ORIGINATION FORM

Proposed Revisions to a Standard Plans Index
(Please provide all information — Incomplete forms will be returned)

Index Number: 646-001

Index Title: NEW: Aluminum Pedestals and Posts - Pedestrian Detectors and Signals ➕

| LAST REVISION 11/01/20 | REVISION | DESCRIPTION: | **FDOT** | FY 2021-22 STANDARD PLANS | ALUMINUM POST AND PEDESTALS MOUNTED PEDESTRIAN DETECTORS AND SIGNALS | INDEX 646-001 | SHEET 1 of 1 |

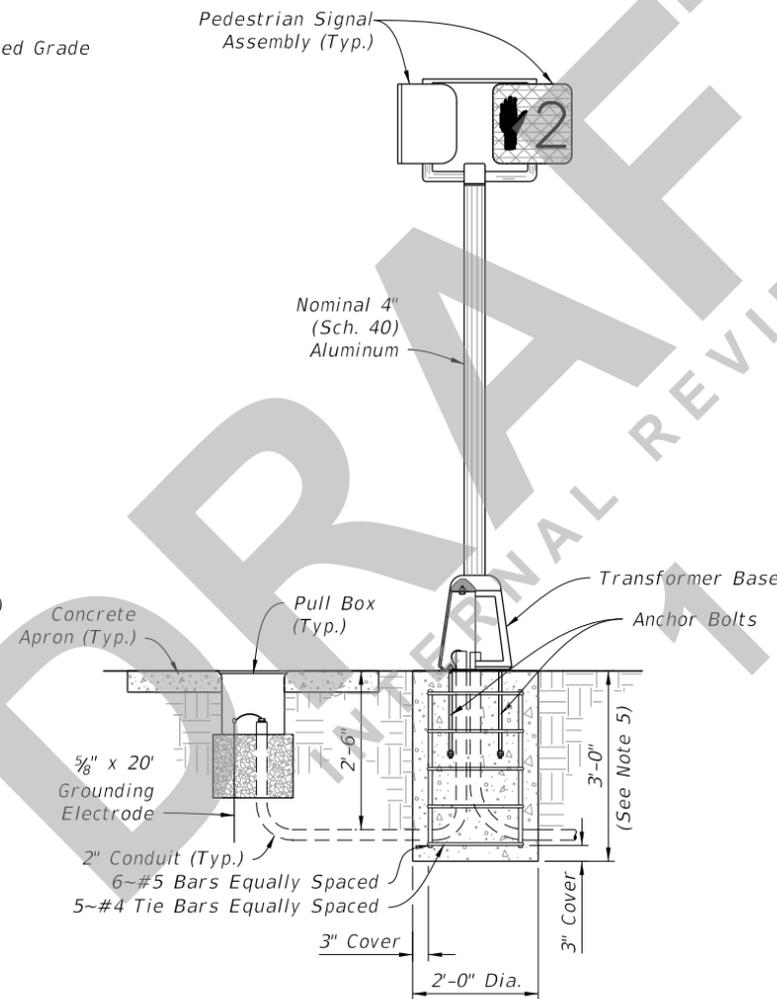
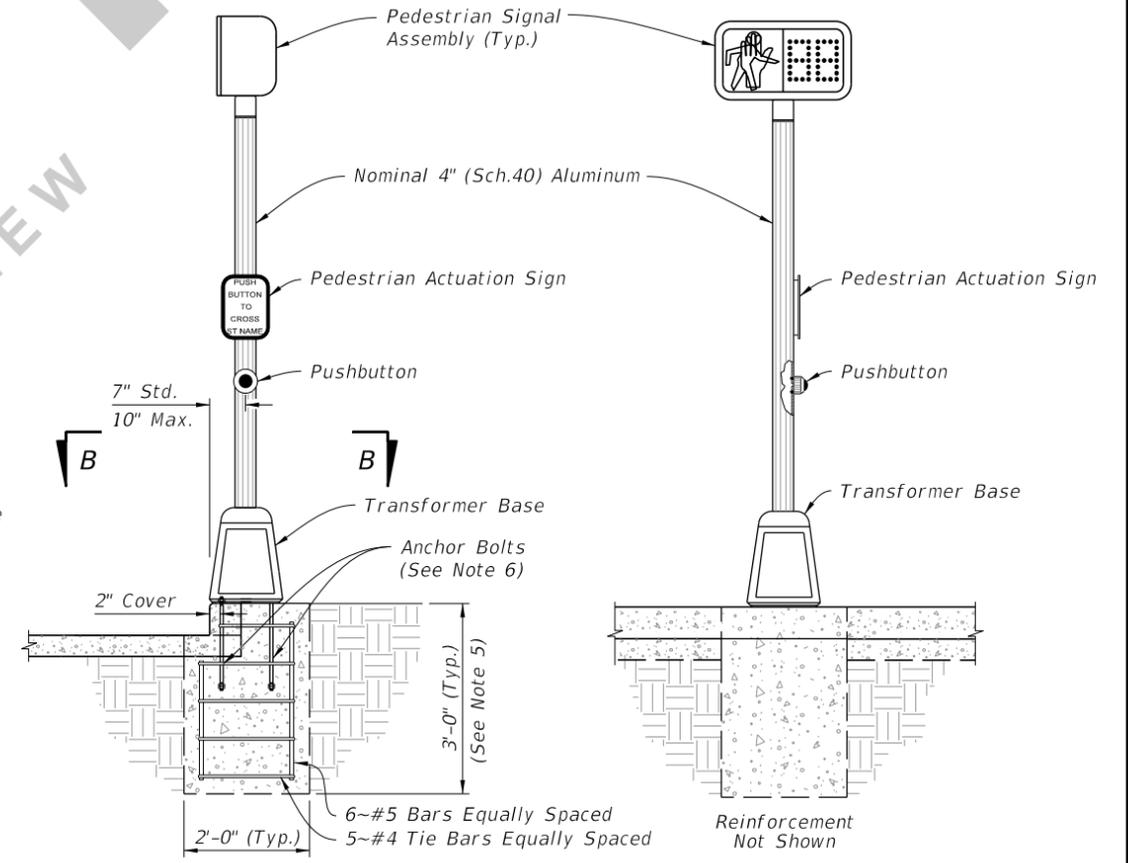
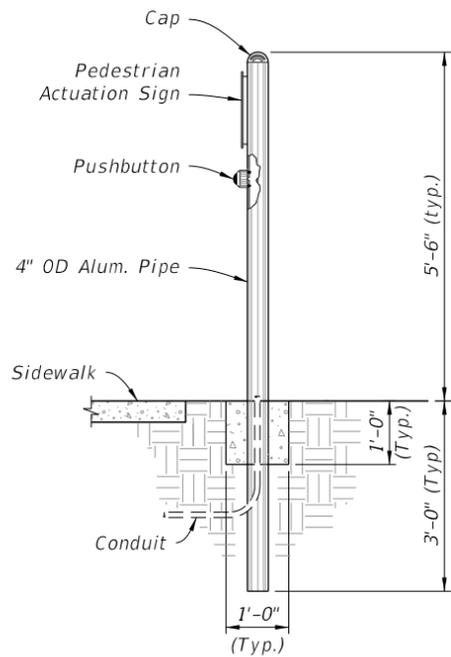
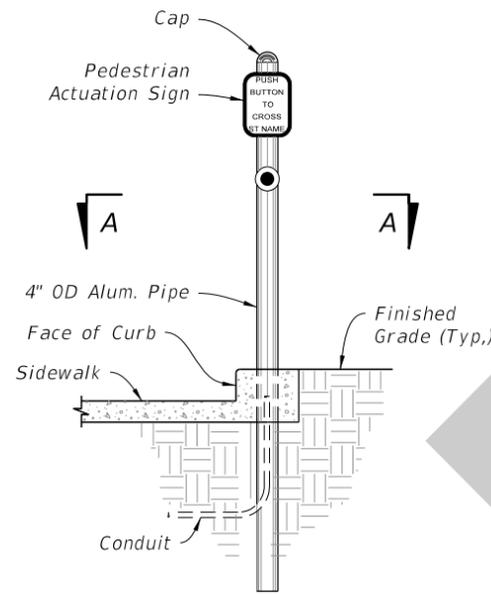
New Index created to consolidate the details of Aluminum Pedestals and Posts used for Pedestrian Signals and Detectors. Existing details are relocated in this New Index from Indexes 653-001 and 665-001. New details have been created to address the foundation and placement details for Pedestals installed with Sidewalk Curb. These were added to prevent pushbuttons from being located greater than 10" from the sidewalk landing.
